## Addendum 03

<b>Project:</b>	2nd floor addition at 56 Edilcan Drive, Vaughan, for Accord Plastics	<b>Date:</b>	05 April 2024
<b>Project No.</b>	2231	<b>Pages incl. cover:</b>	17

Architect in Charge: Workshop Architecture Inc.	Electrical Addendum	EAD-1 (Addendum #3)
	Issue Date:	April 5, 2024
Project: <b>Accord Vaughan, 56 Edilcan Drive, Concord</b>	Project Number:	2023-1010

MAD-2 (Addendum #3)

**2 COMPRESSED AIR PIPING DIAGRAM**  
SCALE: N.T.S.

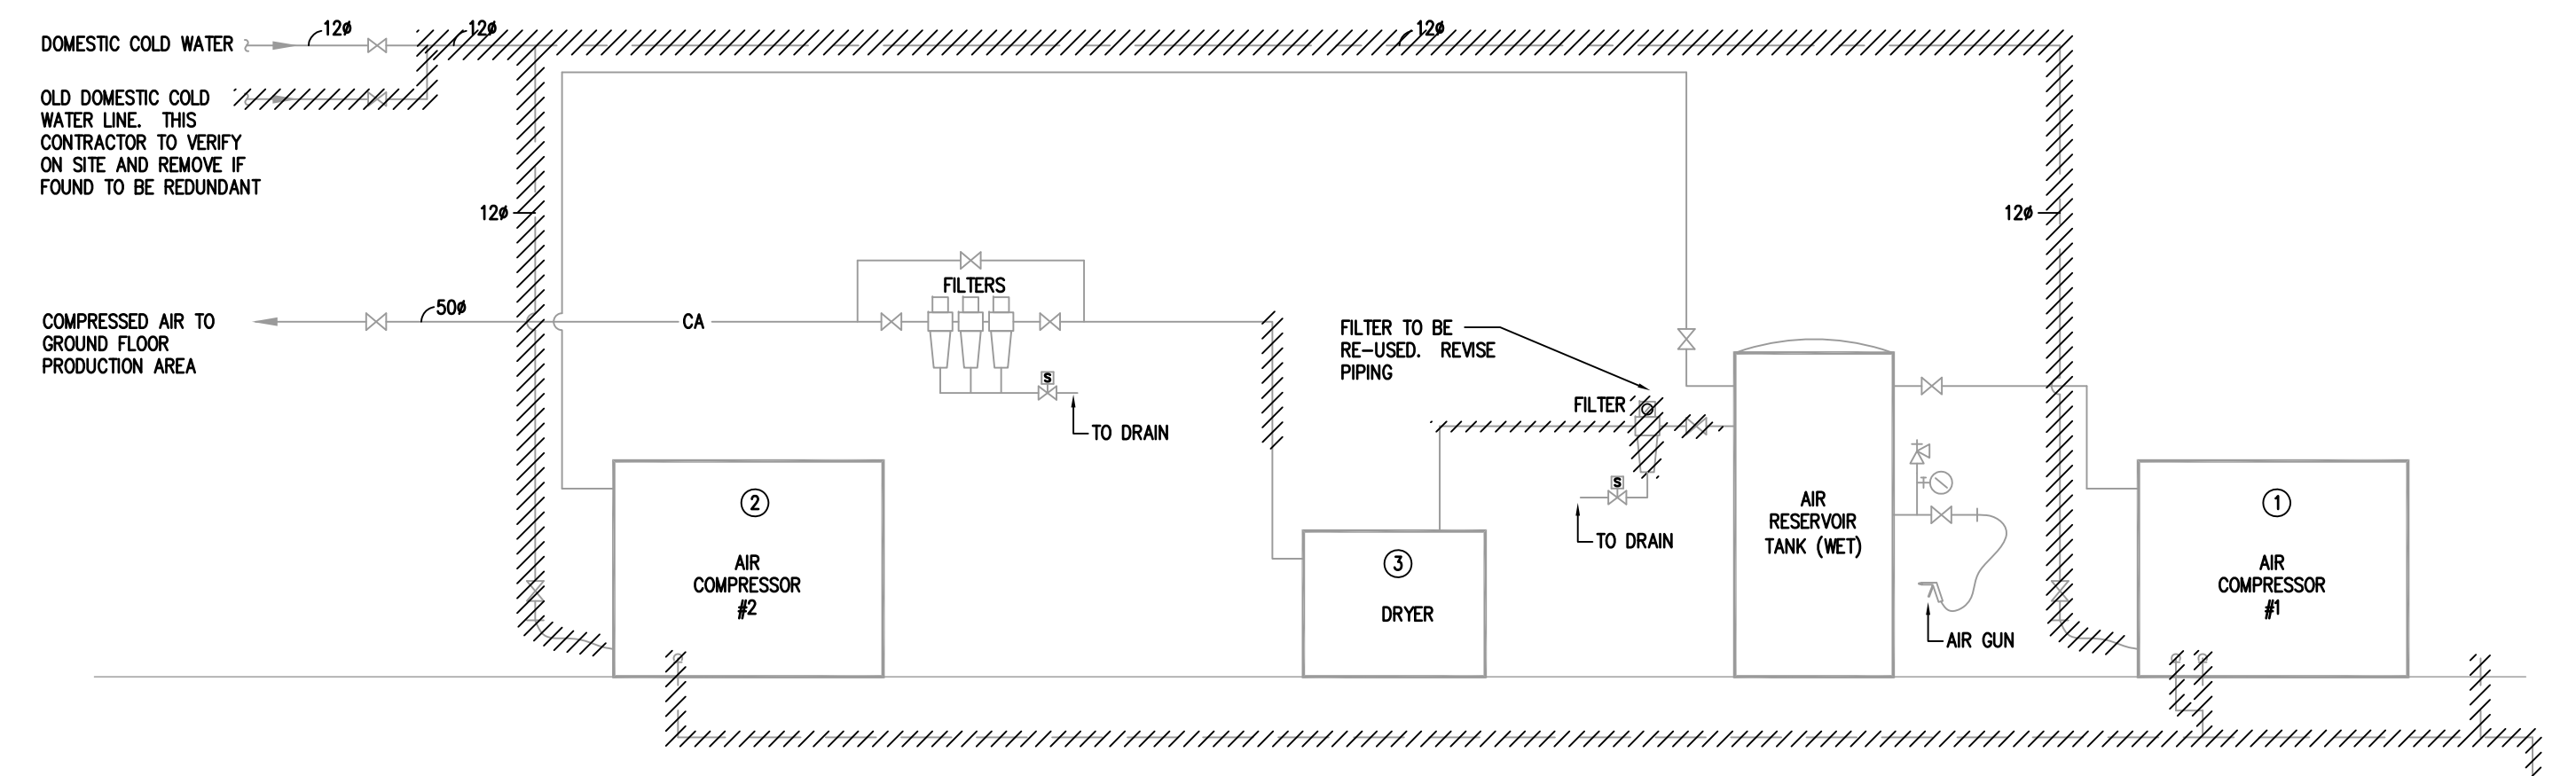
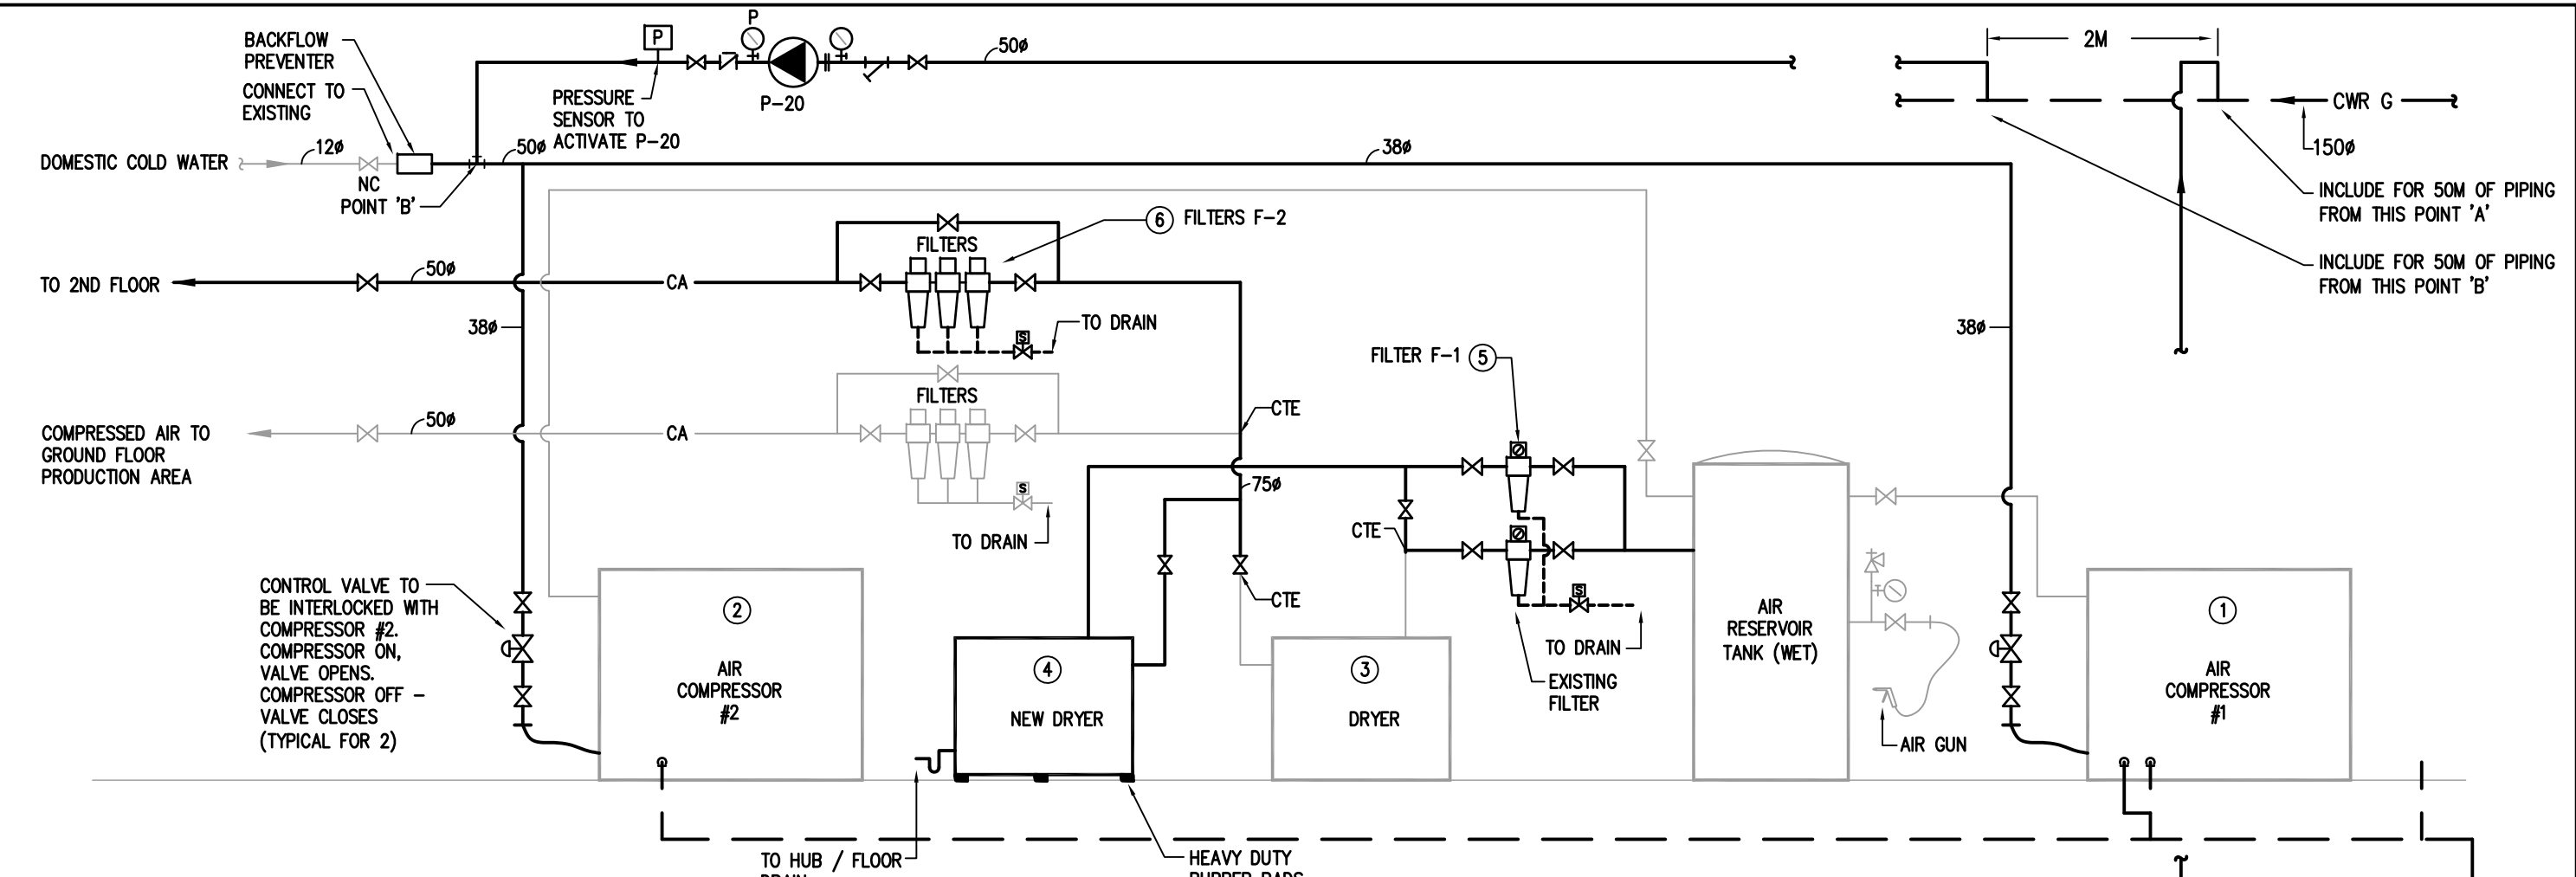
1.2 Diagram on detail 2 is revised.

1.3 All revisions shown on diagram are revised on floor plan. Floor plan is not issued in this addendum
